DESCRIPTION OF REQUEST: Minor Subdivision Preliminary/ Final Plat Approval

**RE: REQUEST FOR MINOR SUBDIVISION
PRELIMINARY/FINAL PLAT APPROVAL
DRB PROJECT NUMBER 1002445- FOOT HILLS SHOPPING CENTER
PROJECT: SNOW HEIGHTS TR 1 & 2, BLK88**

Plat of
Tracts 1 and 2, Block 88
Snow Heights Addition
Section 09, Township 10 North, Range 04 East, N.M.P.M.
Albuquerque, Bernalillo County, New Mexico
July 2017

CONCEPTUAL DRAINAGE CONFIGURATION

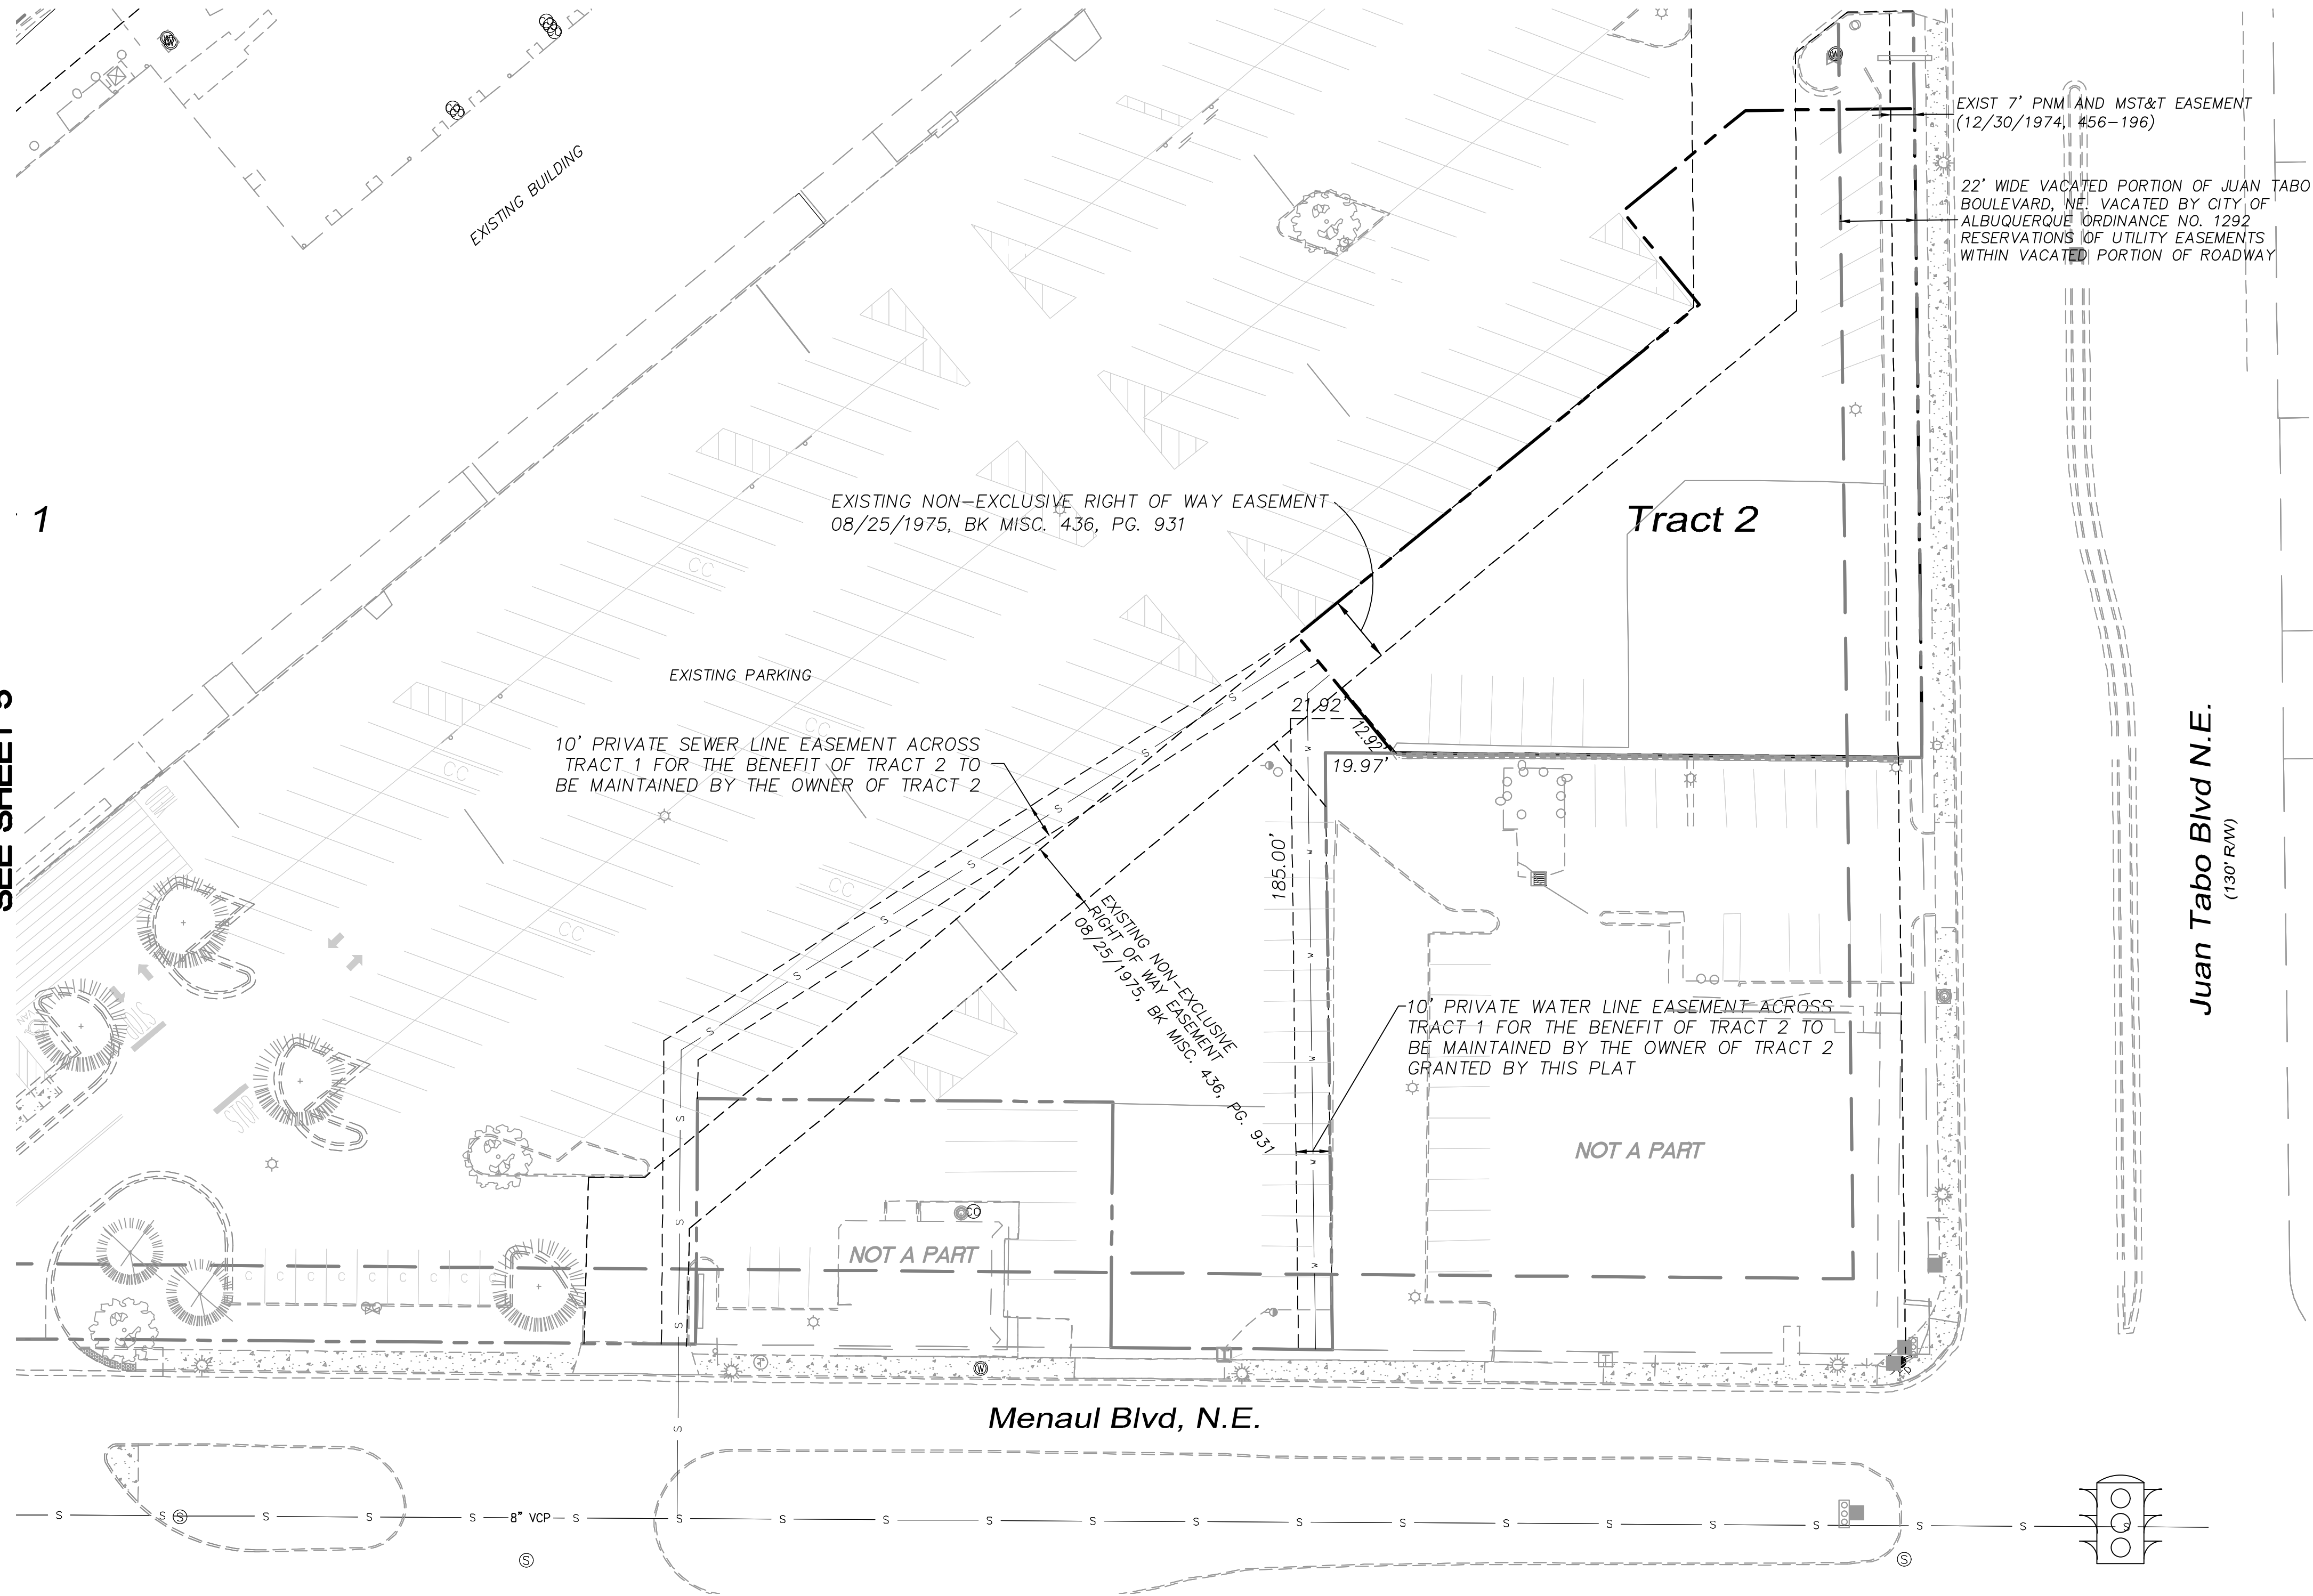
4. An approved grading and drainage plan will be required for Grading/Building Permit
Response: This comment is acknowledged and included in the "Conceptual Drainage Configuration" narrative which appears in the Conceptual Grading and Drainage Plan.

THE PURPOSE OF THIS ADMINISTRATIVE AMENDMENT IS TO DOCUMENT THE PREVIOUSLY APPROVED CONFIGURATION OF PROPOSED TRACT 2 WITHIN THE EXISTING FOOTHILLS SHOPPING CENTER AND TO ALLOW FOR A REPLATING ACTION: NO CONSTRUCTION IS PROPOSED WITH THIS PLAN. THE SITE IS DEVELOPED AND MOST RECENTLY MODIFIED BY A BUILDING EXPANSION PER GRADING AND DRAINAGE PLANS WITH STAMP DATE 7/21/11 AND DRAINAGE REPORT IN FILE (H21/D043). TRACT 2 LIES WITHIN BASIN A OF THE REFERENCED DRAINAGE REPORT WITH ASSUMED HYDROLOGIC LAND TREATMENTS OF 10% C AND 90% D.

FUTURE DEVELOPMENT OF TRACT 2 WILL REQUIRE DEVELOPMENT AND APPROVAL OF A DETAILED GRADING AND DRAINAGE PLAN WITH ANALYSIS TO DEMONSTRATE EITHER HISTORIC DRAINAGE CHARACTERISTICS WILL BE MAINTAINED, OR DOWNSTREAM CAPACITY ANALYSIS FOR CHANGED CONDITIONS FOR APPROVAL BY THE CITY OF ALBUQUERQUE. ONSITE RETENTION/DETENTION MAY BE REQUIRED WITHIN TRACT 2 AT TIME OF DEVELOPMENT IN CONFORMANCE WITH THE DRAINAGE ORDINANCE FOR FIRST FLUSH TREATMENT REQUIREMENTS.

Plat of
Tracts 1 and 2, Block 88
Snow Heights Addition

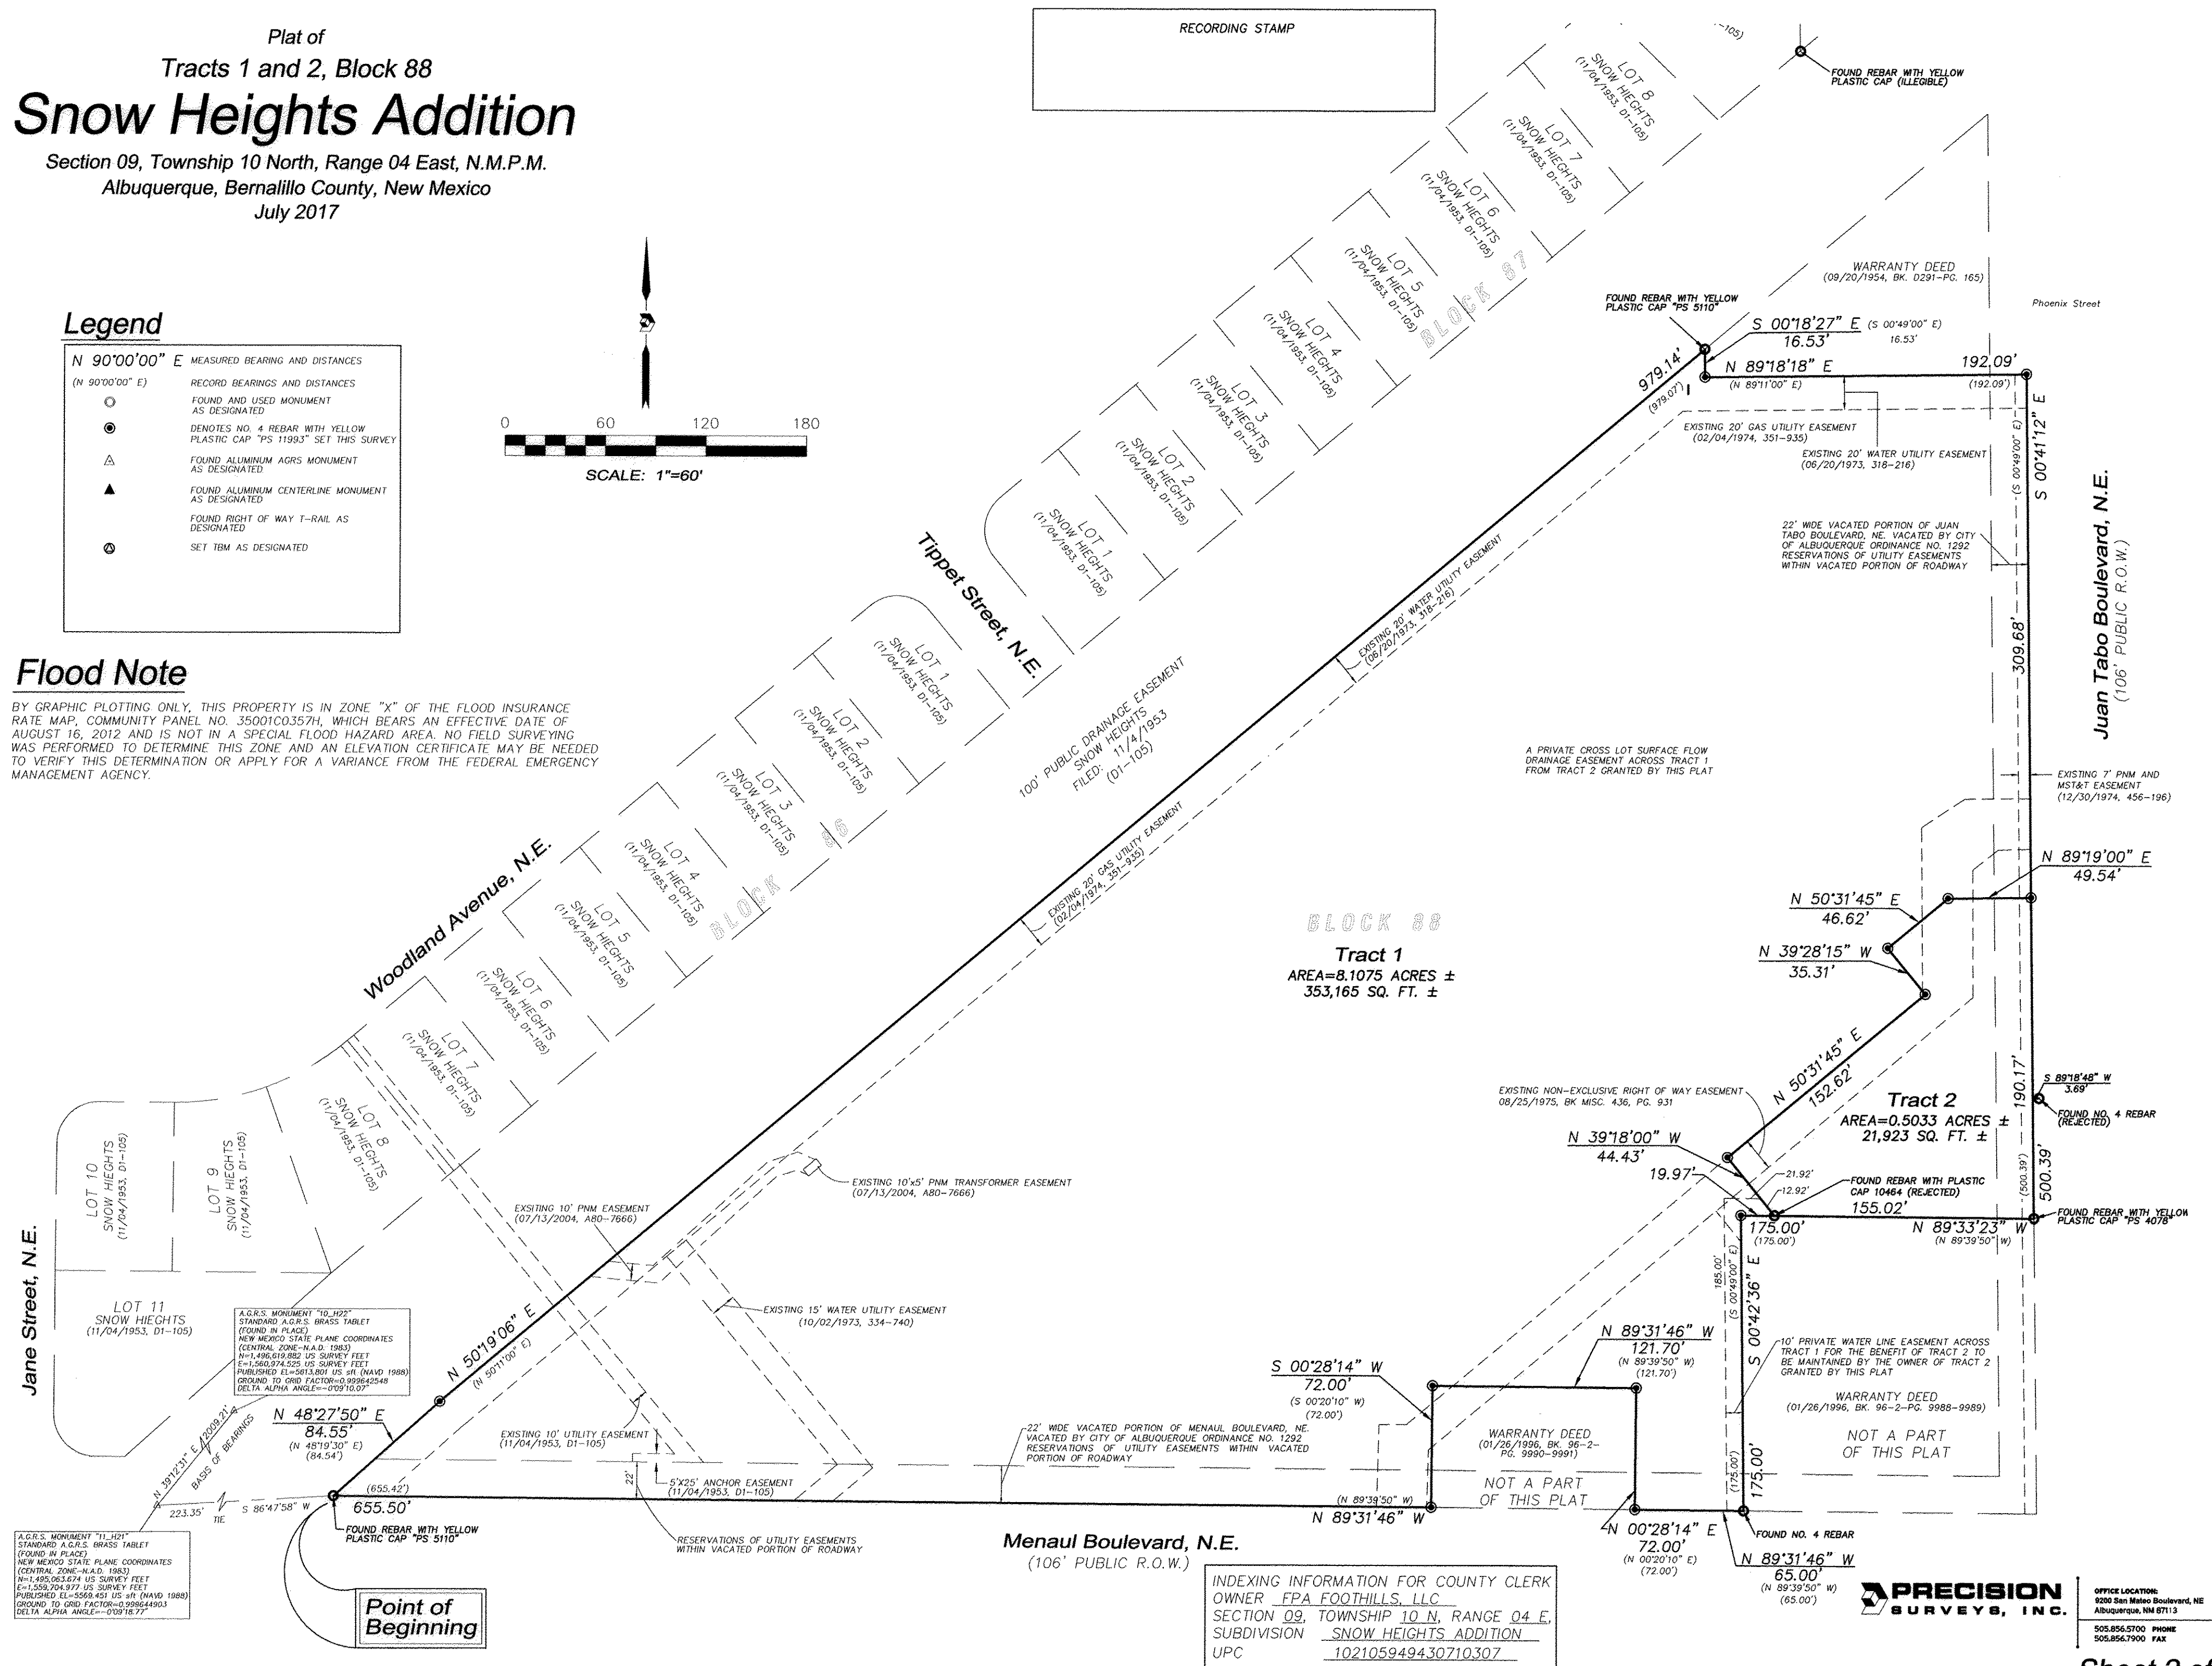
1. Add Flood Plain note & FIRM information (Zone X)
Response: The note was added to the second page of the plat.
2. Cross-lot drainage easement is required (assuming scheme is to continue draining to the parking lot to the west.)

2. Consider granting a 10' private water easement across Tract 1 for the benefit of Tract 2 to permit access to water facilities in Menaul Blvd. There is no option for water service to Tract 2 from Juan Tabo Blvd.

Response: A private cross lot drainage easement is shown on the plat on page two that allows drainage from the new tracts across Tract 1.
3. An approved conceptual grading and drainage plan will be required for Site Plan or Site Plan Amendment

Response: An easement is shown and granted on page 2 of the plat
